City of Carlisle, Iowa
Planning and Zoning Commission
Regular Meeting
July 18, 2022

RE: Ridgewood Valley Plat 1 – Construction Drawing Review
PROJECT #7023.057

RE: Ridgewood Valley Plat 1 – Final Plat Review
PROJECT #7023.058

FINAL PLAT

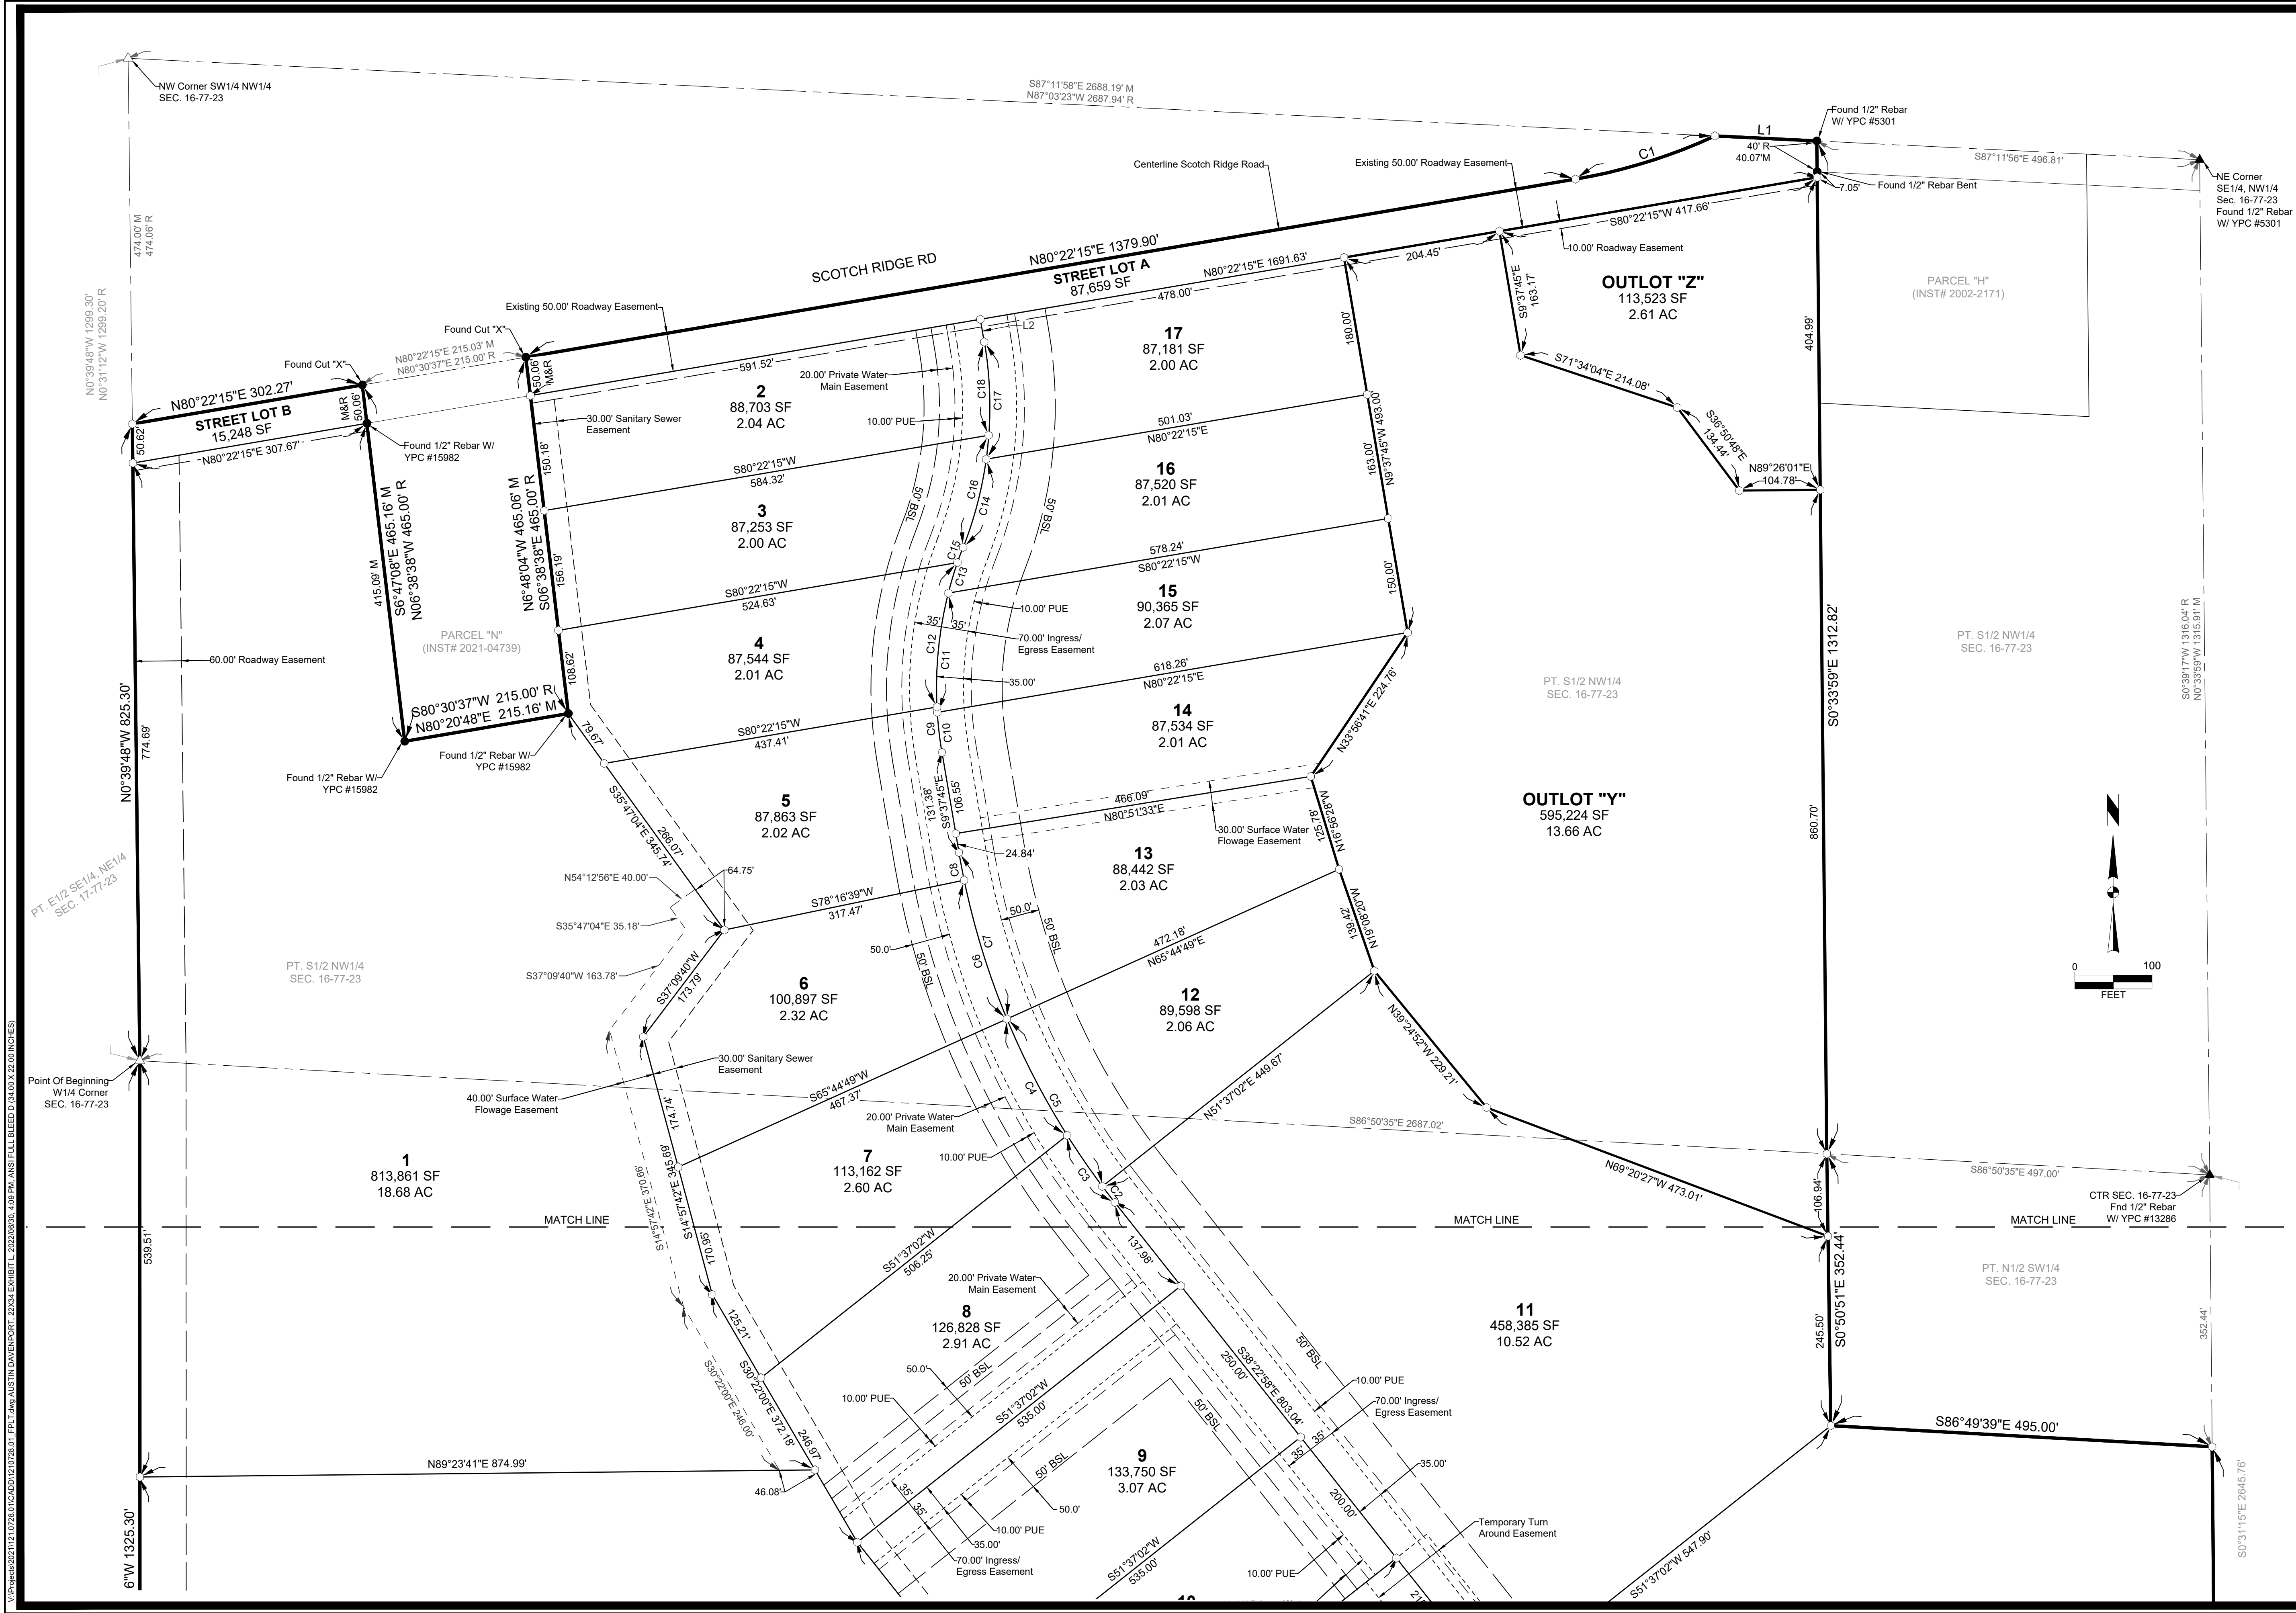
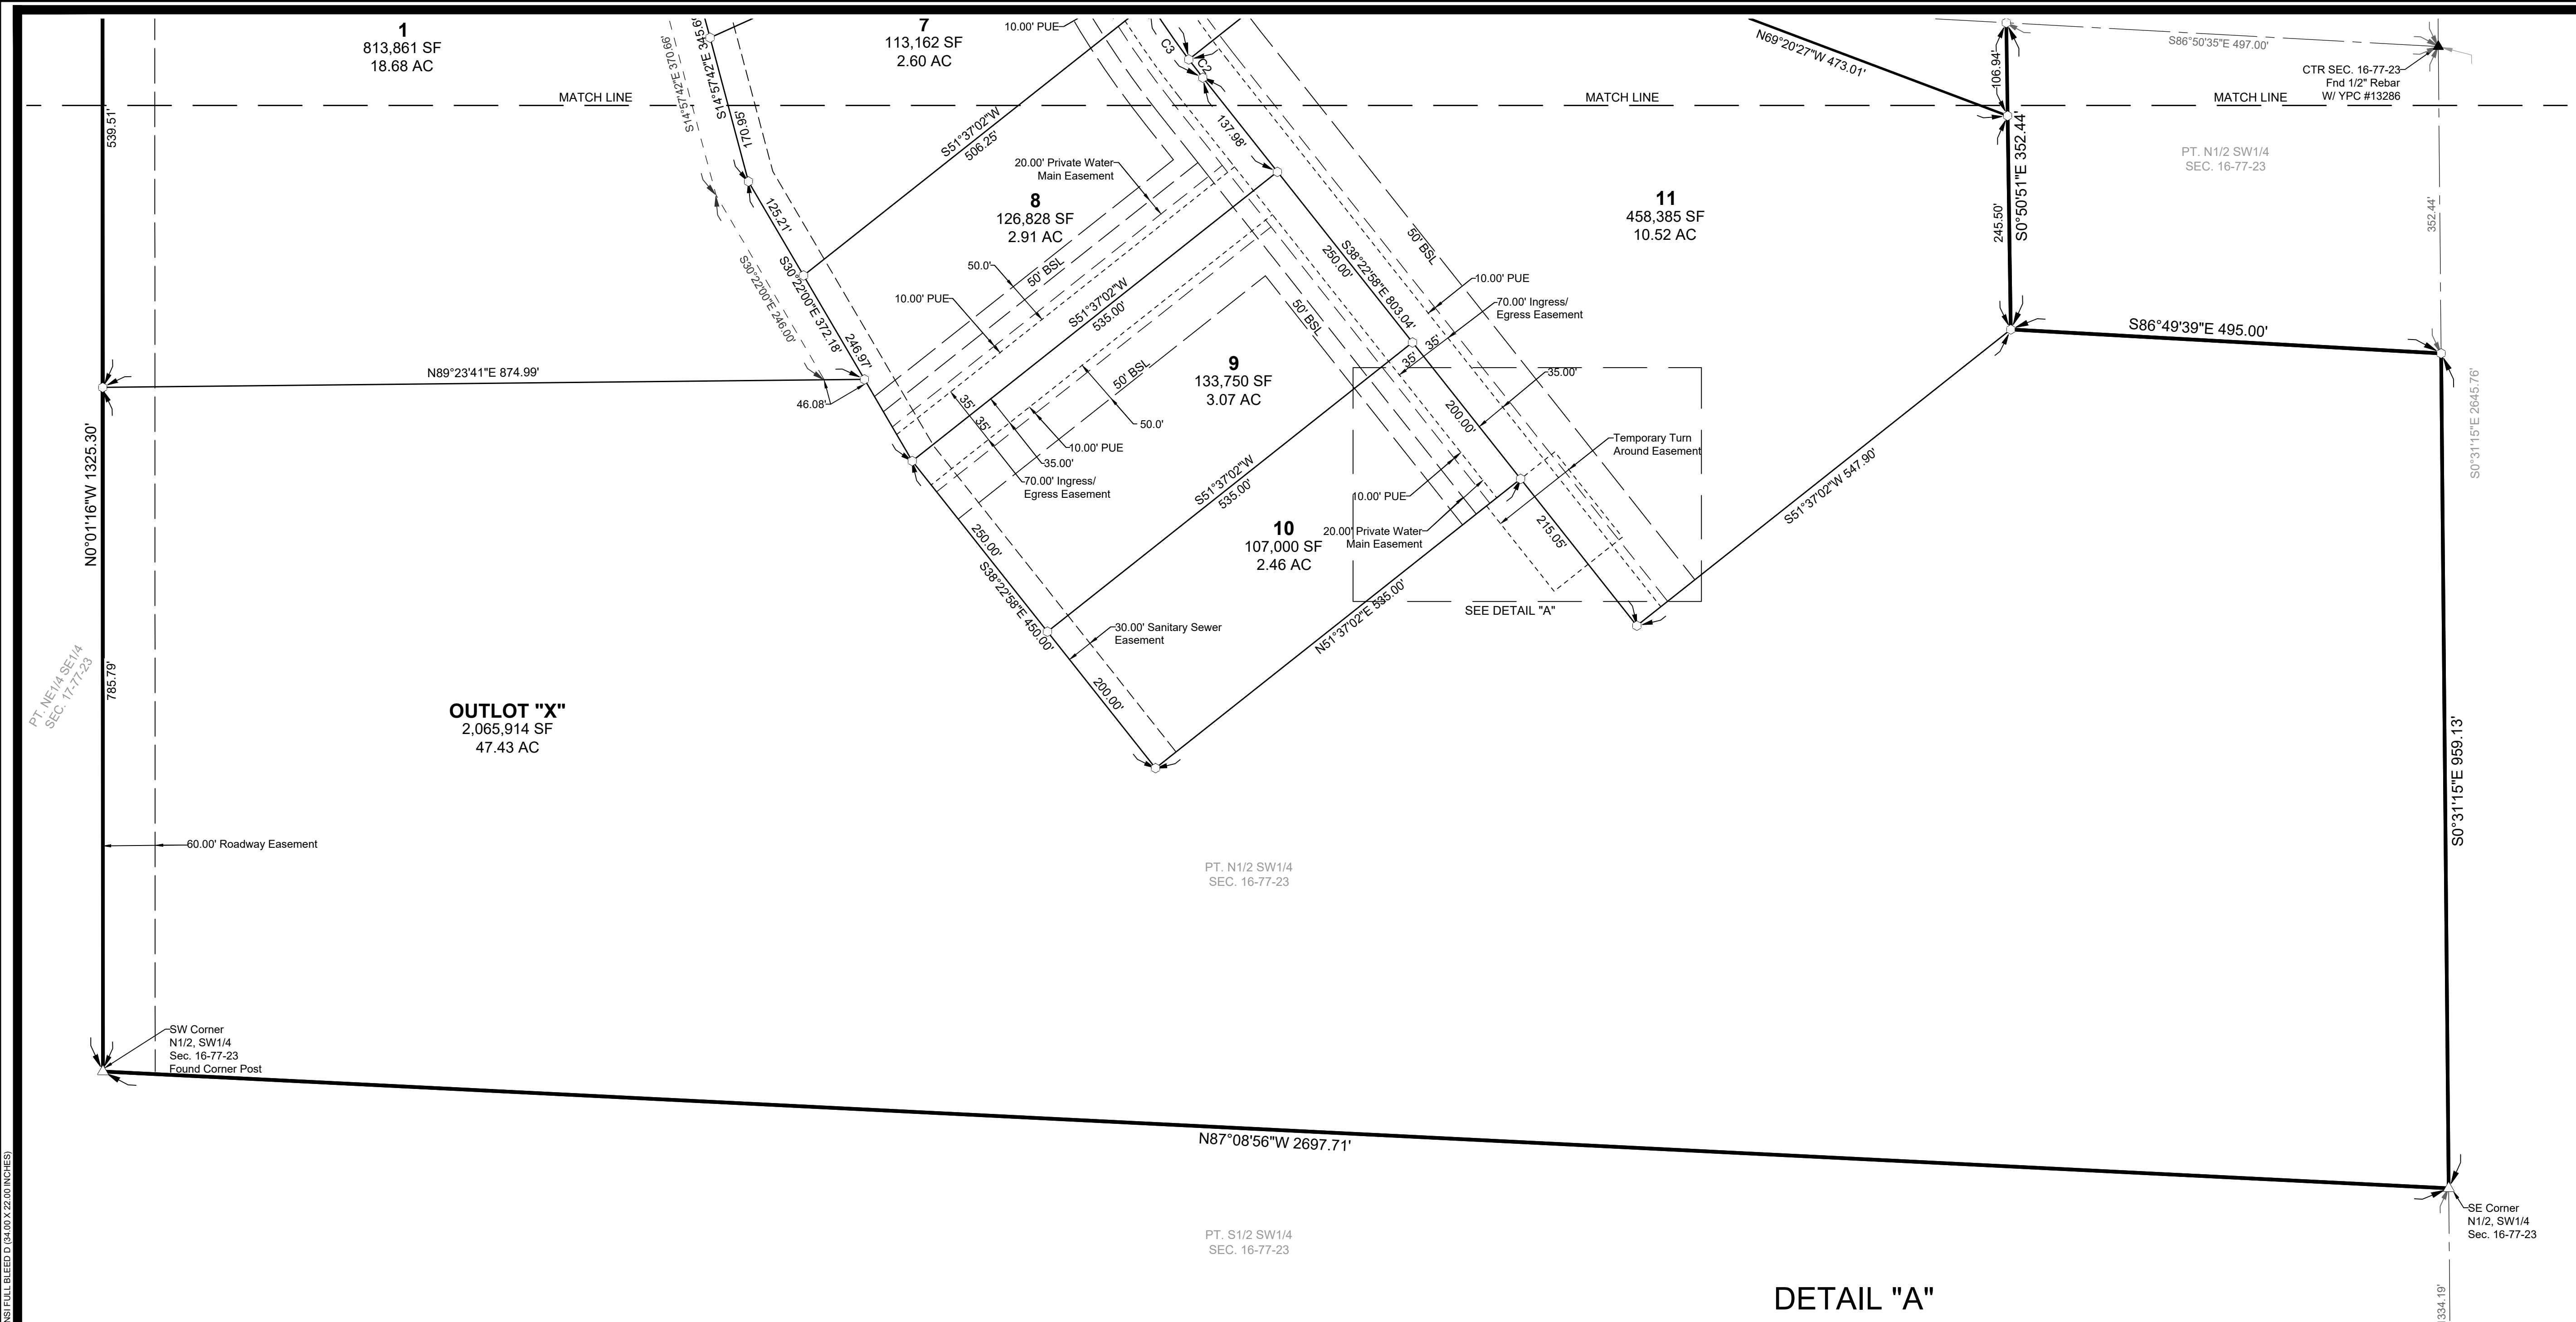
- a. The plat is missing the name of the private street. (Carlisle 180.09(2)(N))
- b. Please add basis of bearing to the plat notes. (Carlisle 180.09(2)(O)(1))

- c. Please label recorded bearing and distance on the segment of 1/4, 1/4 line between the NW Corner of Parcel H and the NE Corner SE1/4, NW1/4. (North line of Parcels H & J) (Iowa 355.8(a))

- d. Please label the acreage for each 1/4, 1/4 section in which this plat lies, including existing ROW acres. (Iowa 354.6(3))
- e. Please reconcile the bearings along the north line of the S1/2, NW1/4. The plat shows three different bearings along that line, including line L1 from the line table. The plat description should be revised accordingly (L1 call).

- f. The NE Corner of the subdivision is also the NW Corner of Parcel H. Please revise the corner label accordingly to show common corner. Likewise, please modify the labels at the corners of Parcel N accordingly to match the plat description.

- g. The plat shows a 30' wide surface water flowage easement following the common line between Lots 13 and 14. Please add to the label that the easement is taken 15' from each lot.

- h. For the bearings shown running along government lines outside of the subdivision, please consider using a darker text for measured dimensions. This text will be lost with subsequent scanning and photocopies of the plat.

- i. Please consider using a heavier, darker line for the symbols of set corner monuments. This detail will be lost with subsequent scanning and photocopies of the plat.

- j. Please add acres of existing public right of way contained within this development to the plat description.
- k. Please add a note pertaining to the purpose of Outlots X, Y and Z.

- l. Please add set corner monument labels to each location where the lot lines intersect the proposed right of way of the private ingress/egress easement. (Iowa 355.6(2))

- m. Please consider revising the corner monument symbols for the lot corners running down the center of the proposed private street to reflect a monument other than a set pin as the intention is to pave the road surface.
